ADDENDUM NO. 01

**Montgomery County Educational Service Center
Northridge High School Renovation
2251 Timber Lane
Dayton, Ohio 45414**

LPA Project No. 93304.00

1.1 Reference: Drawing A202A

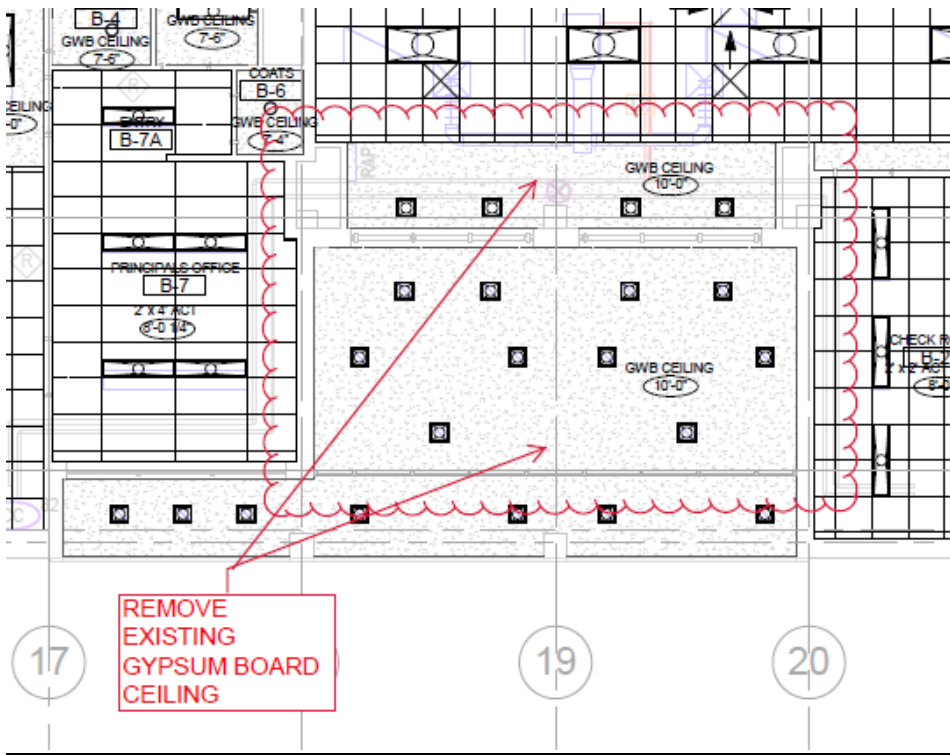
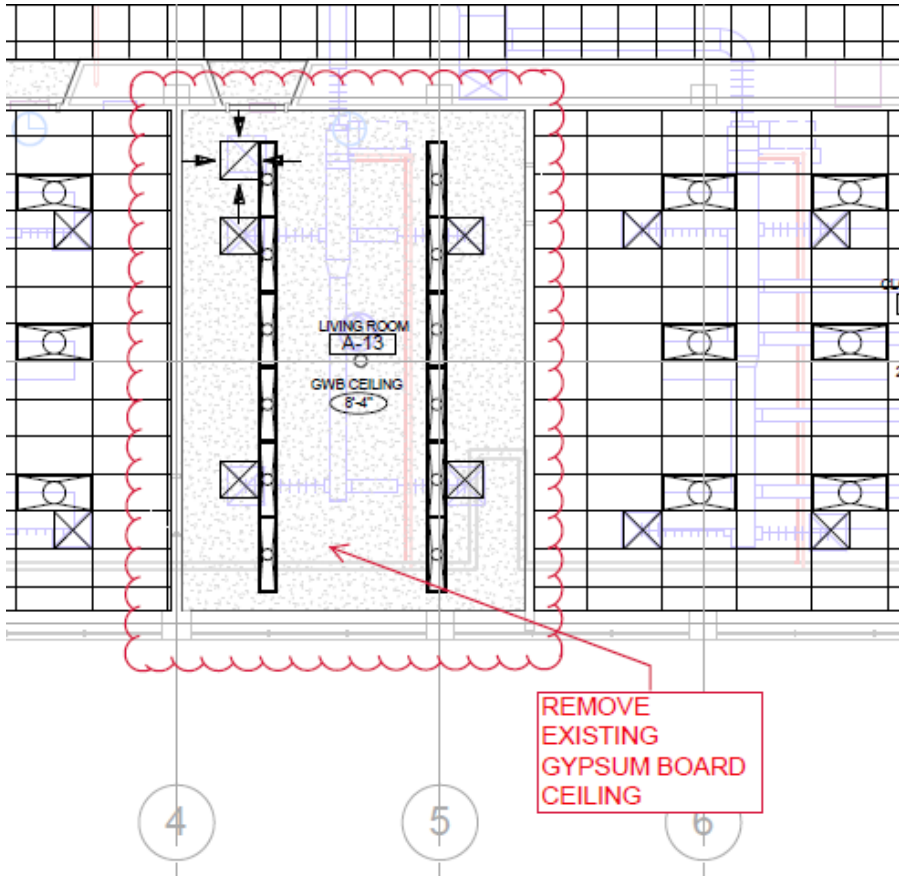
- A. Delete elevation tags shown in Library Room B203. Those tags are meant for the interior elevations of the Third Floor Restrooms that are located directly above this room.
